**Comments on the Addendum to Draft Final Proposal on Lowering Bid Floor**  
**Department of Market Monitoring**  
**October 10, 2016**

**Figure 1. Frequency of 5-minute intervals with power balance constraint violation in CAISO  
(from ISO's Addendum to Draft Final Proposal, p, 8)**

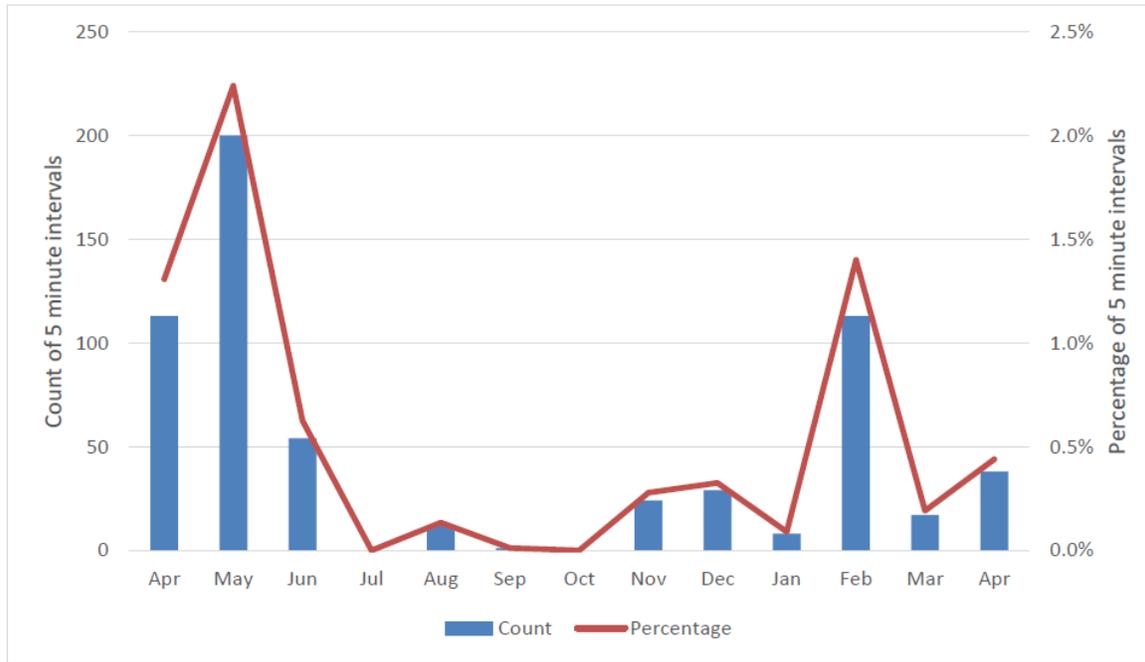
Figure 1 below shows Figure 1 from the *Draft Final Proposal*, while Figure 2 shows DMM’s analysis of these same data over a longer period of time through September 2016. The ISO’s analysis indicates that during February 2016 the frequency of power balance constraint relaxations due to an excess of energy rose to about 1.2 percent of 5-minute intervals.

However, as shown in Figure 2, DMM’s analysis indicates that during this month the power balance constraint was relaxed due to an excess of energy during only about 0.1 percent of 5-minute intervals (or 4 intervals). After correcting for this apparent miscalculation and viewing this metric over a wider period of time, the data in Figure 2 suggest a clear trend that the frequency of power balance relaxations due to excesses of energy is very low and decreasing in 2016 compared to last year – despite the significant increase in solar and hydro energy in 2016 noted in the ISO’s *Draft Final Proposal*.

**Figure 3. Frequency of curtailed self-schedules**  
 (from ISO's Addendum to Draft Final Proposal, p,9)

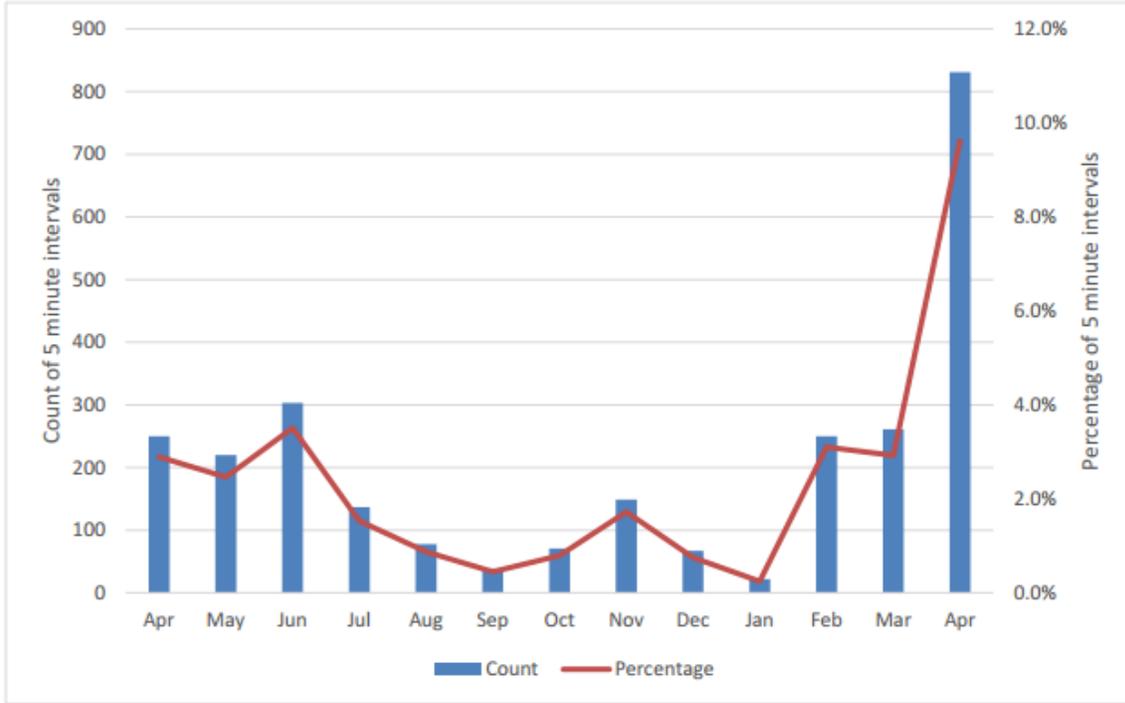
The second metric presented by the ISO in support of its initial recommendation to lower the bid floor is the frequency of self-schedule curtailment in terms of the percentage of intervals during which any self-schedule was curtailed in the ISO system. The ISO's analysis is provided in Figure 3 below.

DMM believes this second metric used by the ISO – the frequency of intervals when any self-schedule is curtailed – is not a good indicator of the actual sufficiency of decremental bids or the potential benefits of lowering the bid floor for two reasons. First, as noted by the ISO, this metric does not differentiate between curtailments to address system wide over-supply versus very local issues that can often be resolved by curtailing a very limited number of resources. Second, the metric does not take into account the volume of curtailments.

As shown in a comparison of Figures 3 and 4, the data in Figure 4 on the volume of curtailments suggest a declining trend in the volume of curtailments, while the ISO data in Figure 3 was cited in the *Draft Final Proposal* as indicating that self-schedule curtailments will increase.

**Figure 4. Total volume of curtailed self-schedules**

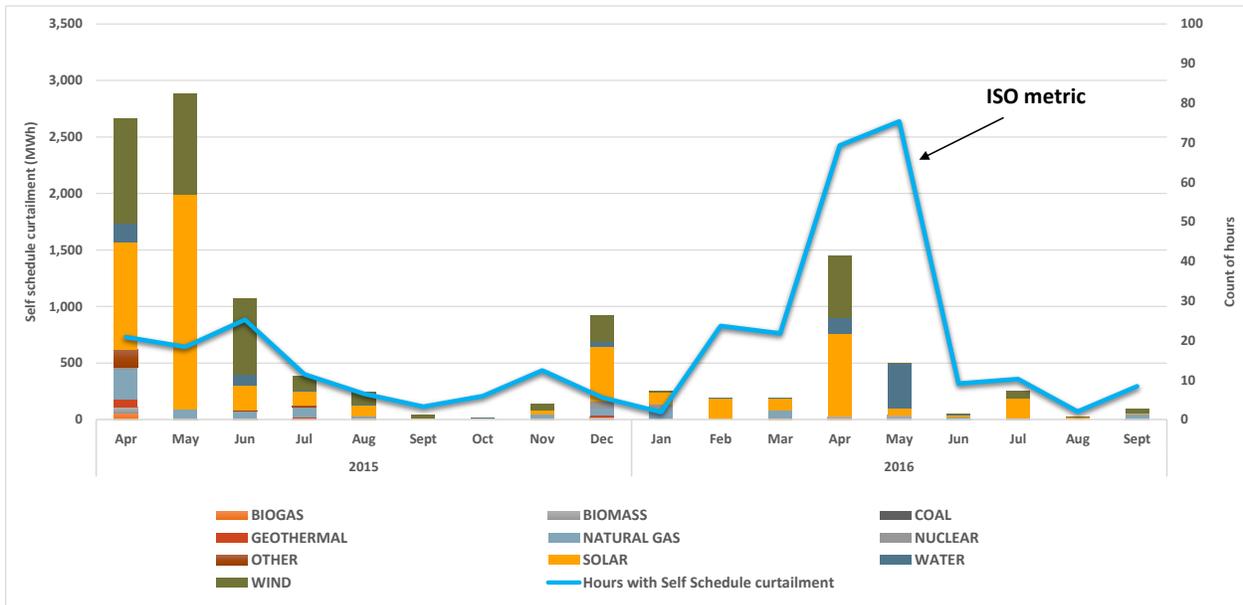
DMM's review of these data indicate that in fact, most of the curtailments counted in the ISO's analysis – especially in 2016 – are very small curtailments of solar, wind and hydro resources in local "generation pockets" with limited transmission. This is reflected in Figure 4, which compares the ISO metric (the frequency of intervals with any self-schedule curtailment) to the total volume of curtailments. Figure 4 also provide this analysis through September, while data in the *Draft Final Proposal* stops in April 2016.
